Deferred Submittal Requirements and Application

Preliminary Structural Checksheet Response

Permit #: 15-248958-DFS-01-CO

LEVEL 01 BCI JOIST LAYOUT
FILE: 16-001323 JOB: DOZER CONSTRUCTION
FENWICK APARTMENTS

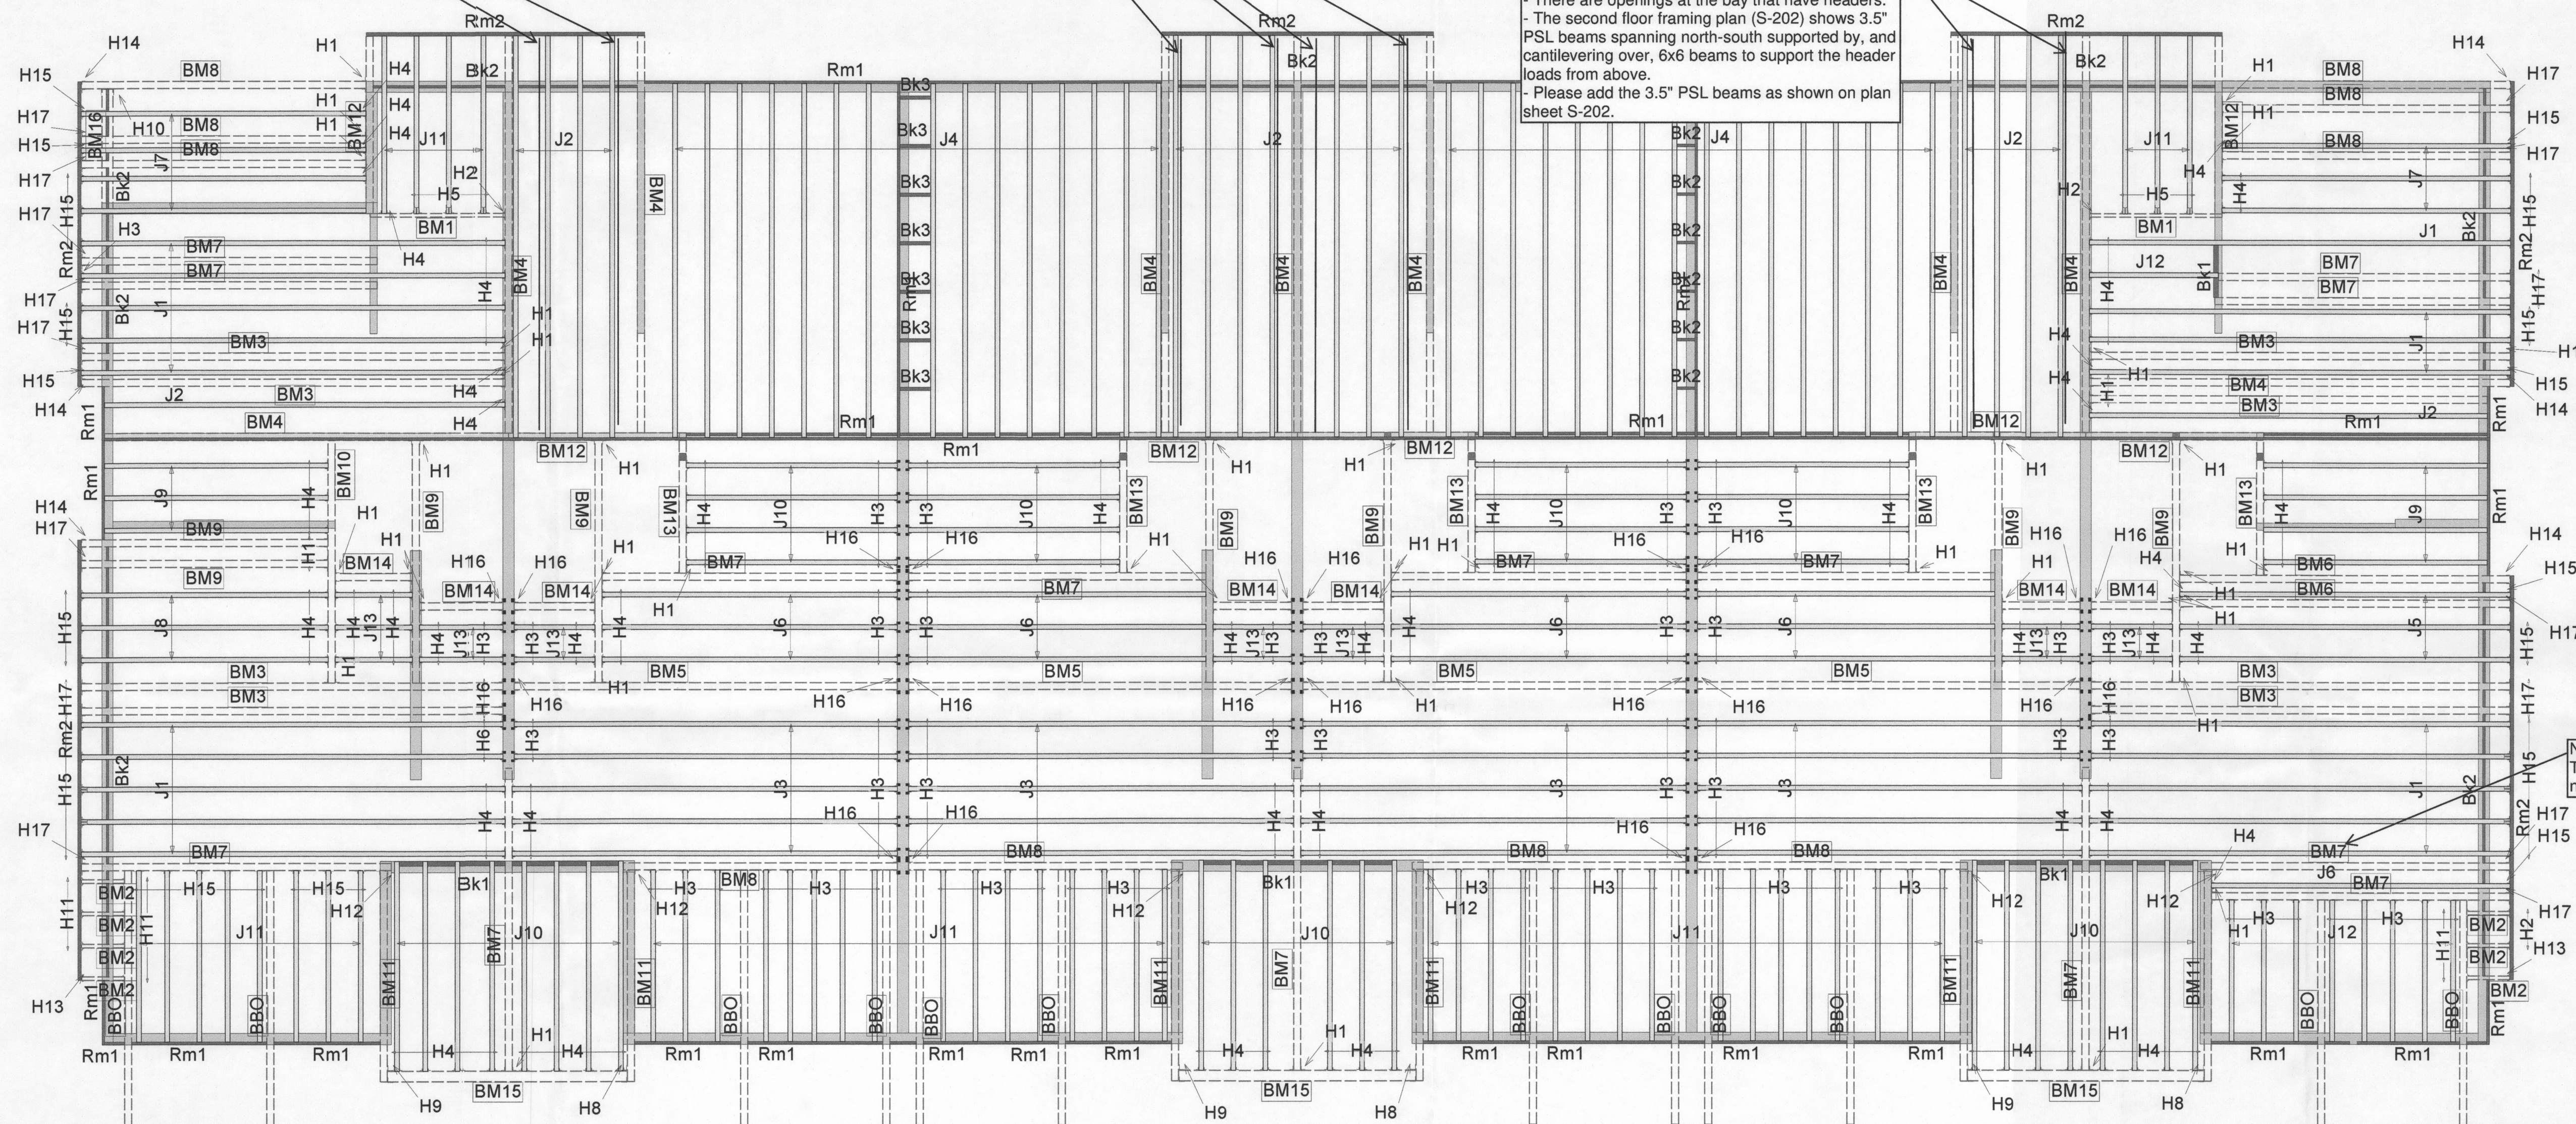
Please Note :
- At the third floor framing plan (S-203) the floor joists span to, and are supported by, the north bay wall.
- There are openings at the bay that have headers.
- The second floor framing plan (S-202) shows 3.5" PSL beams spanning north-south supported by, and cantilevering over, 6x6 beams to support the header loads from above.
- Please add the 3.5" PSL beams as shown on plan sheet S-202.

UPPER LEVEL BCI JOIST LAYOUT
FILE: 16-001323 JOB: DOZER CONSTRUCTION
FENWICK APARTMENTS

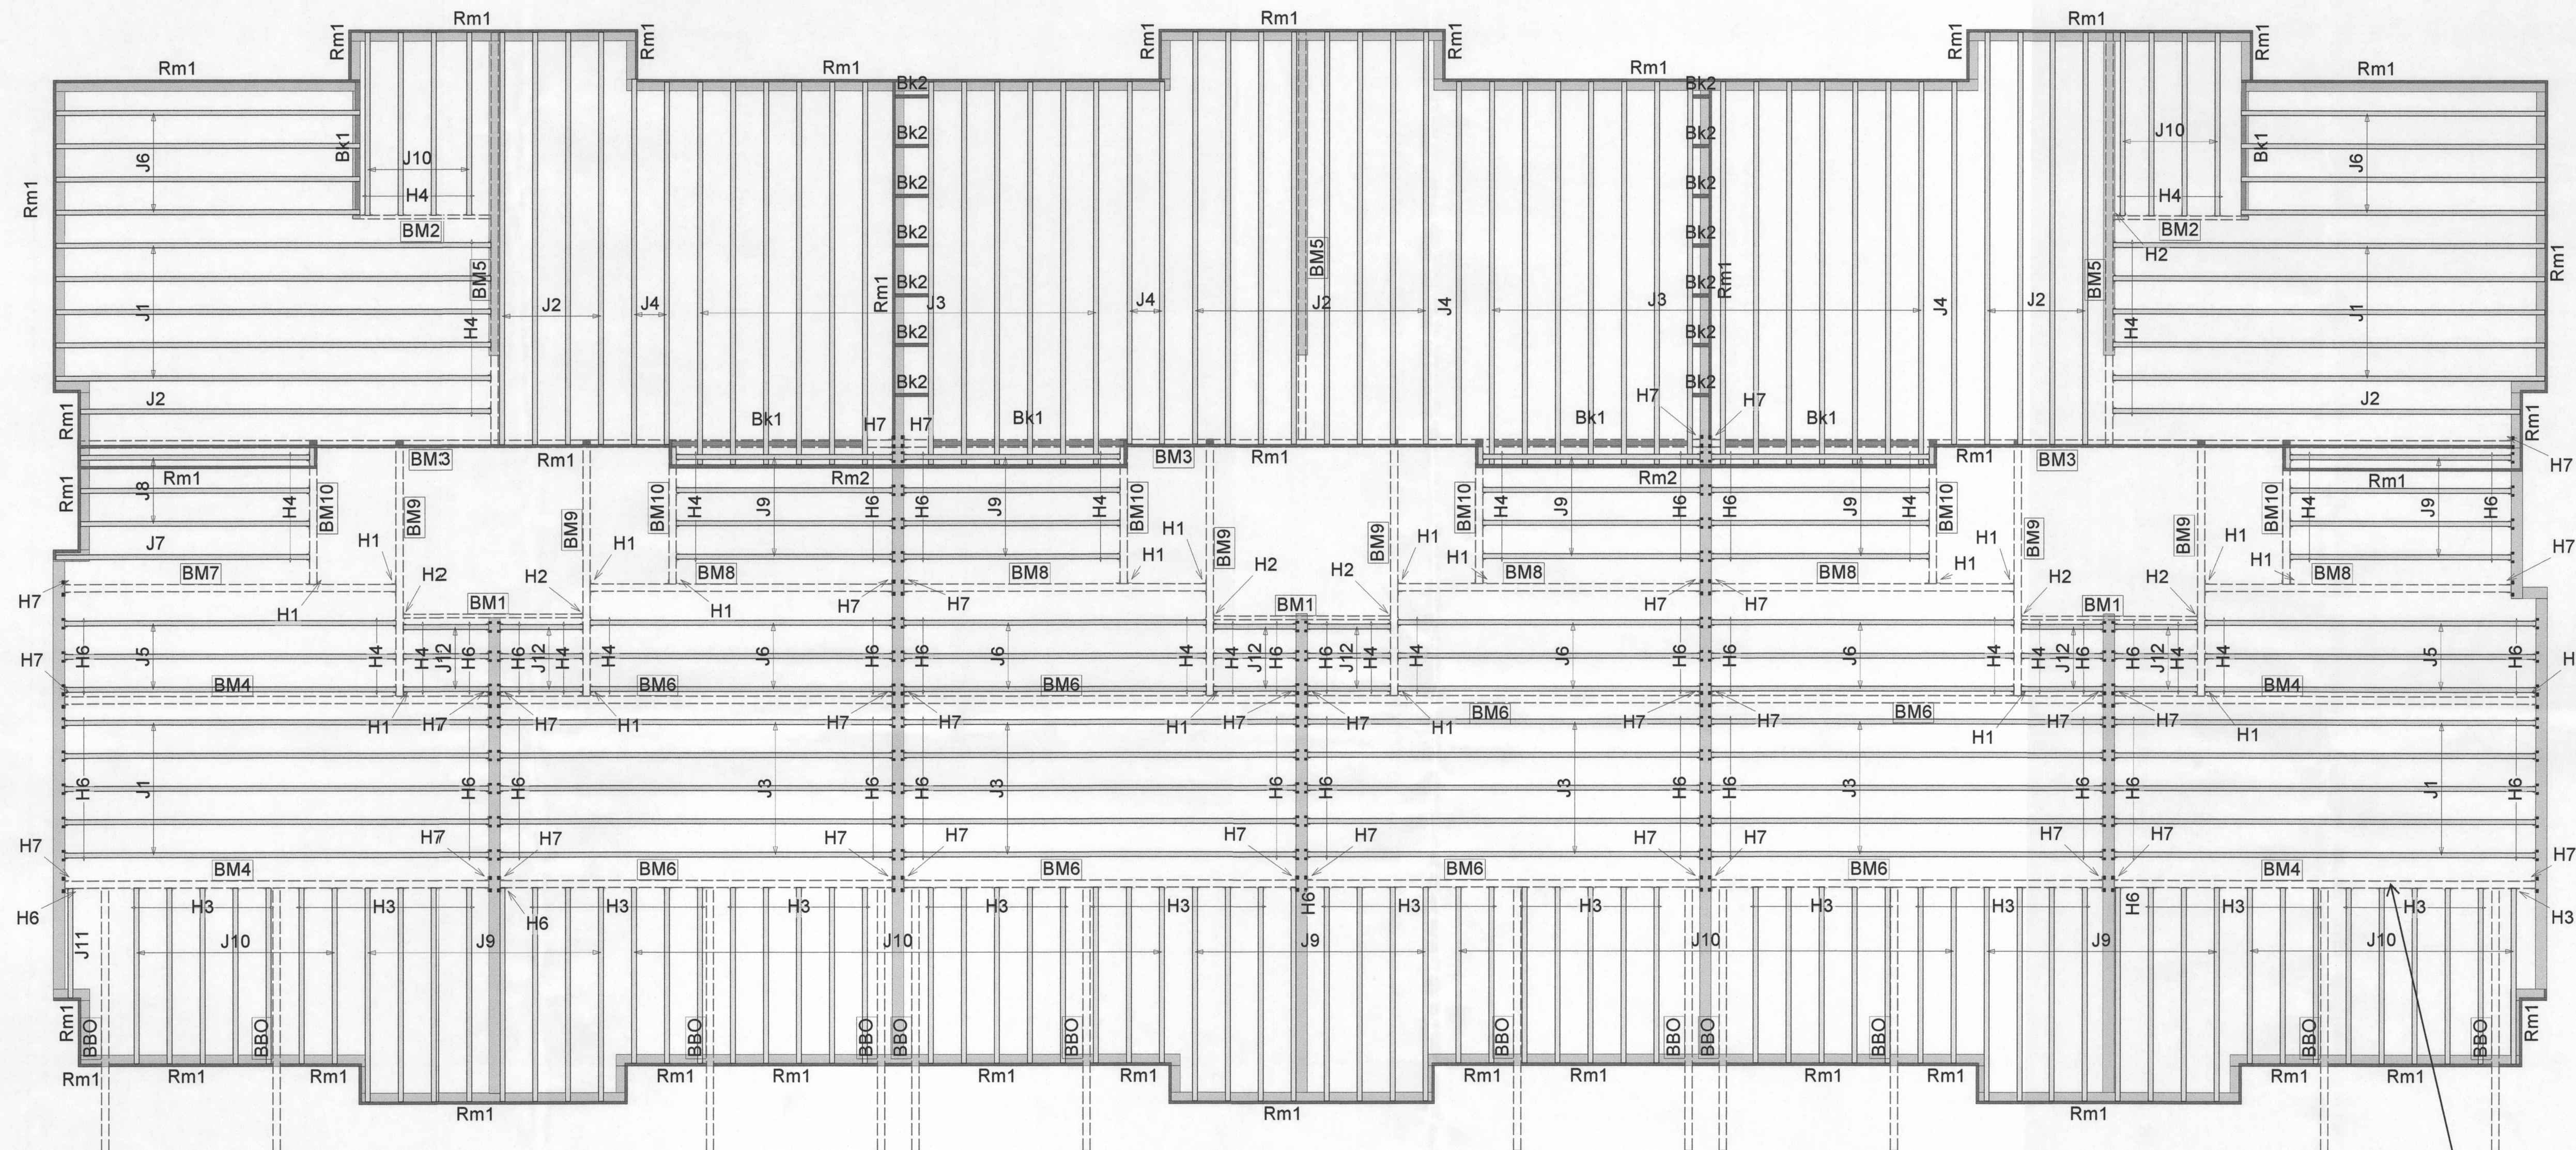
Beam appears to be incorrectly located. Refer to plan sheet S-203.
